FINISHED PRODUCT SPECIFICATION

PRODUCT: MX-1915 SILICATED SUPEREX BLOCKS

PAGE NO. 2.

DATE ISSUED 12/5/50.

B. Dimensional Tolerances

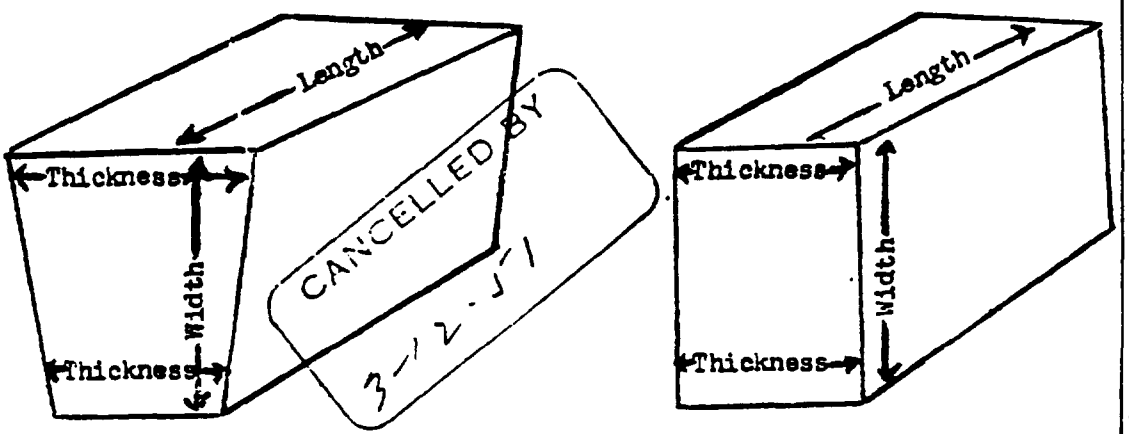
1. Length - +1/16", -1/16"
2. Width - +1/16", -1/16"
3. Thickness - Maximum +1/16", -1/16". Sales Dept. desires +1/32", -1/32"
4. Taper - A sheet metal template of the correct radius shall be used to check tapered blocks for proper fit to the prescribed radius. This template shall be so constructed that a complete radius of blocks may be set up for inspection. Blocks when set up must fit the prescribed template. The maximum gap which is allowable when the blocks are set up on the template shall not be more than 1/16".
5. Block Ends - Shall be square with the long faces to within 1/16" per 6" of width.

X - INDICATES CHANGE - REASON: Change in gap tolerance from 1/32" to 1/16"
